SAFETY DIRECTIVE AV II – 0001

INSPECTION AND/OR MODIFICATION OF CONTROL TUBE ROD END ATTACHMENT

Figure 1

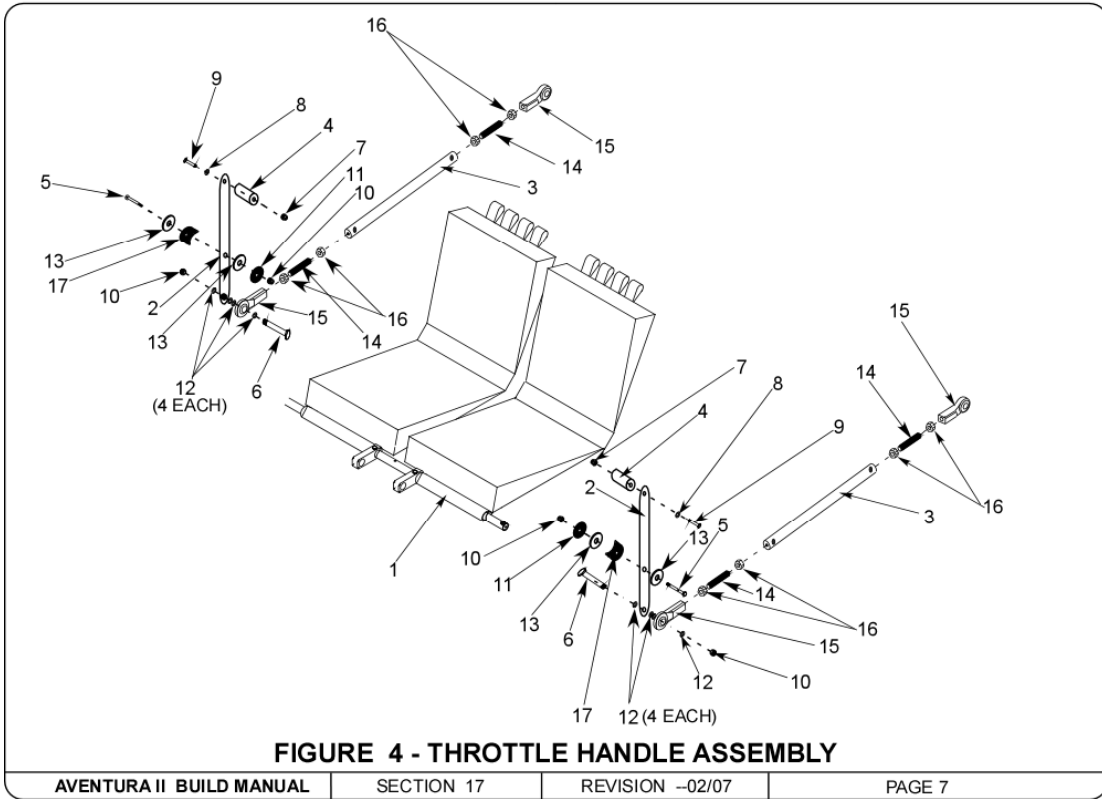
Inspect the Left and Right Dual Throttle Control Tubes (see Fig. 1) to ensure that the threaded inserts are secured to the tube with a solid rivet or an AN3 Bolt and Nut (see Fig. 3).

2.1.4) Any control tube inspected IAW (2.1.1, 2.1.2 and 2.1.3) whose threaded insert is not secured with a solid rivet or an AN3 Bolt and Nut must be corrected.

Figure 2

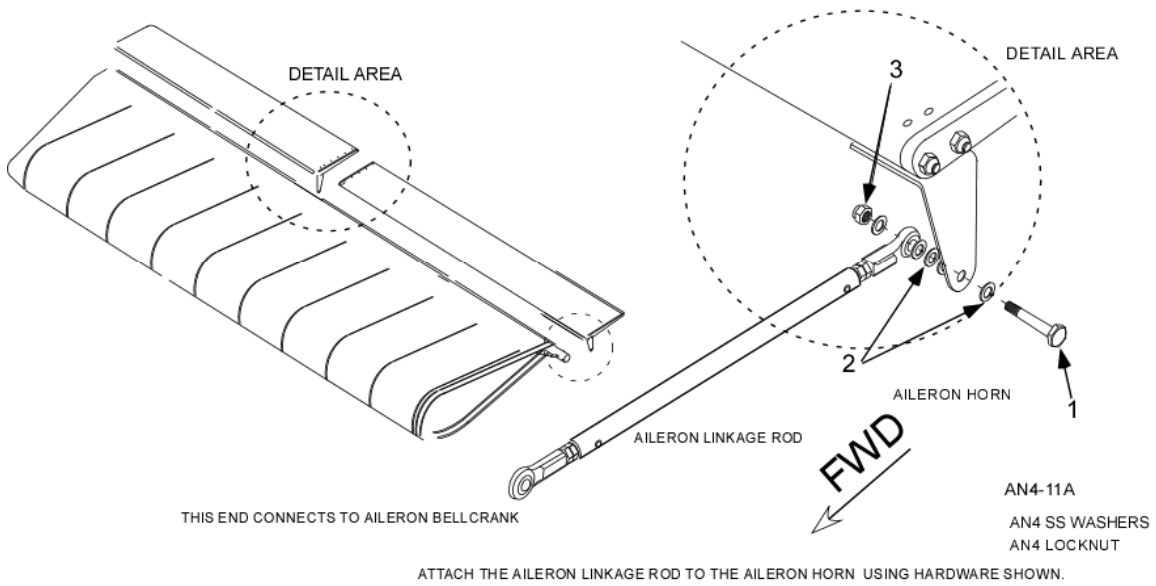
Inspect the Left and Right Aileron Control Tubes (see Fig. 2) to ensure that the threaded inserts are secured to the tube with a solid rivet or an AN3 Bolt and Nut (see Fig. 3).

Figure 3

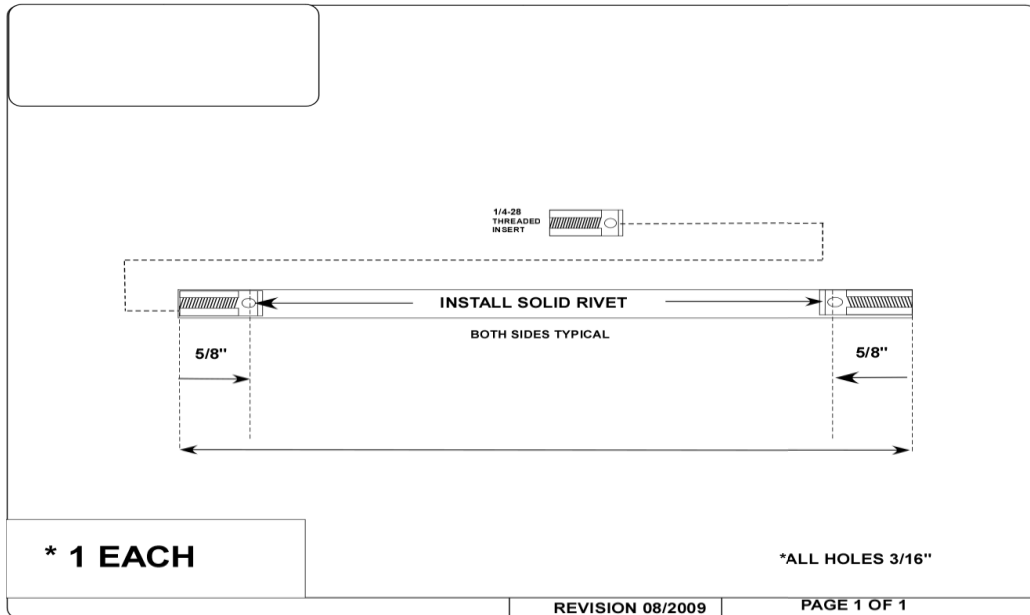
Field experience has shown that connection of the 1/4 - 28 threaded insert (see Fig. 3) on certain control tubes require modification due to the following: 1/4 - 28 threaded insert can separate from the control tube.

Figure 4

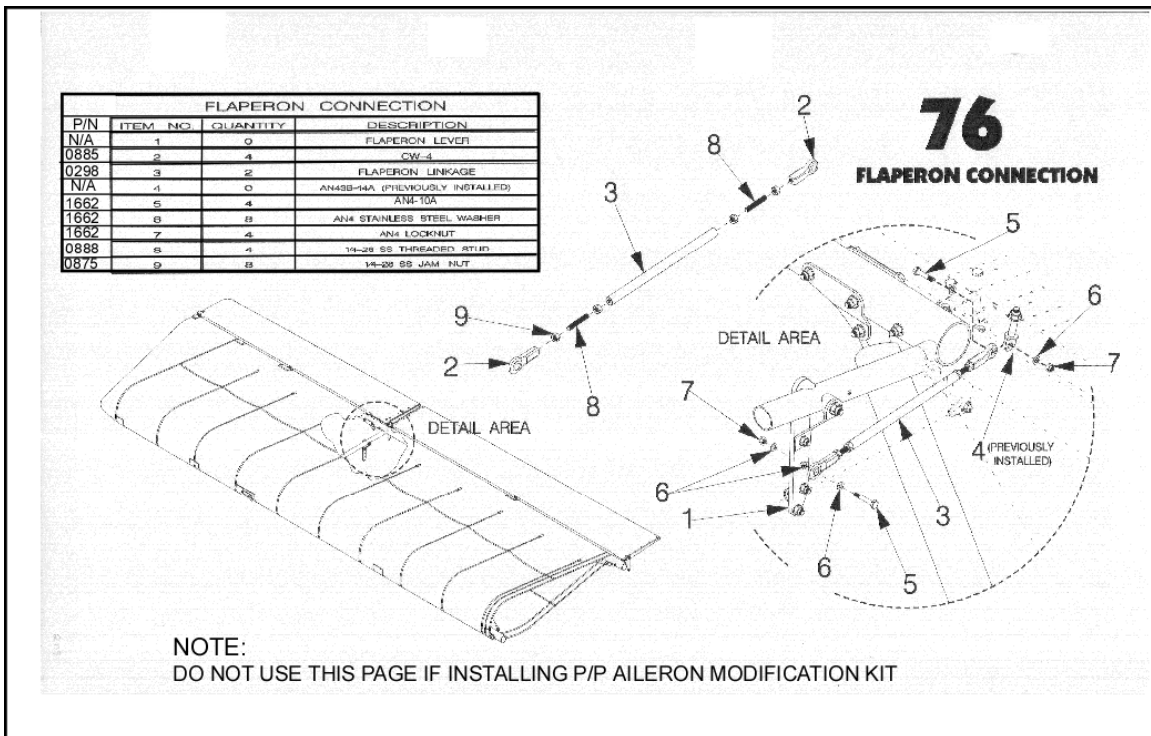
Inspect the Left and Right Flaperon Linkage Control Tubes (see Fig. 4) to ensure that the threaded inserts are secured to the tube with a solid rivet or an AN3 Bolt and Nut (see Fig. 3).
